HISTORIC DISTRICT COMMISSION

June 1, 2023 - 6:00PM Saugatuck City Hall 102 Butler St. Saugatuck, MI 49453

MEMORANDUM

RE: Historic District Permit Application: 149 Griffith Street

PARTIAL EXISTING FRONT **GRIFFITH ST VIEW**

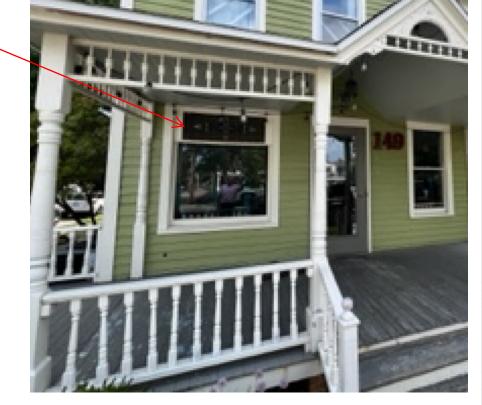
Comment: The applicant wishes to remove the non-original stained glass window panel, as it was not originally intended for the space and was not designed to fit this particular space. The application does not include the replacement window type, and it should be specified by the applicant.

Comment: While the non-original stained glass window is to be removed, the application does not include the replacement window type.

Added a second or additional, or wider stile to the side.

The bottom rail was removed and a in adequate piece of wood was added. This is starting to sag and will not be able to hold the panel up over time.

This top window sash is not original to the building. Someone took a window sash with this stained glass panel and installed it into the opening. There has been some added wood and some wood removed or cut to resize it to make it "fit" (although it doesn't really fit properly) in the opening.

REMOVE ATTACHED NON-ORIGINAL STAINED GLASS -**PANEL**

There is also a significant gap at the meeting rail. The top sash is too tall even after then bottom rail was cut and the ¾" piece was added. This is causing the sash to not meet at the meeting rail. This also leads there to be no way to latch or lock the sashes together.

Added pieces of wood to make it fit. The bottom rail of this window should be 1.25" or more. This has a ¾" piece added with a butt joint in the corner. No mortise and tenon which tells me some one manipulated the sash to make it fire into an opening where it doesn't belong.

EXISTING REAR / MASON ST. VIEW

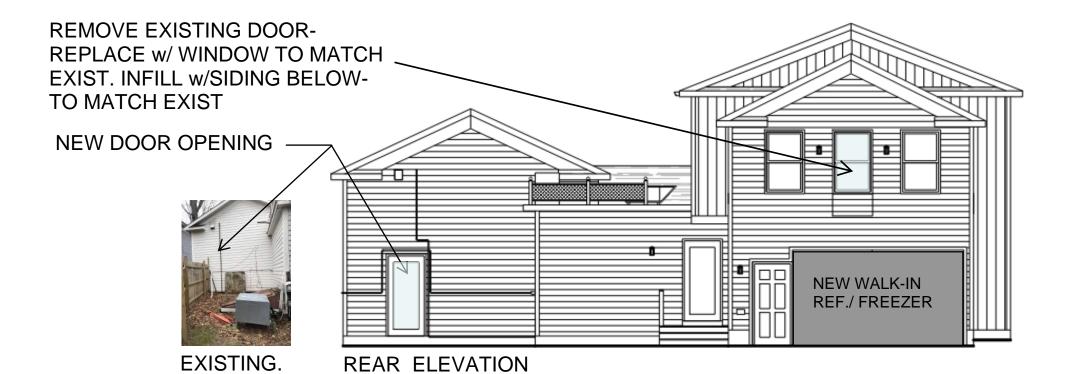
Comment: The second-story door which is to be replaced, does not lead to a deck or stairs. It is proposed to be replaced with a window that matches those on each side. Replacing the door with a window will improve the rear of the building as it currently appears "incomplete" without a deck or stairs.

Comment: The most significant addition is the proposed walk-in refrigerator and freezer. The unit is screened with a lattice-type design with a trellis at the top.

While not a formal building addition, the HDC should determine if the screening treatment is appropriate for the unit.
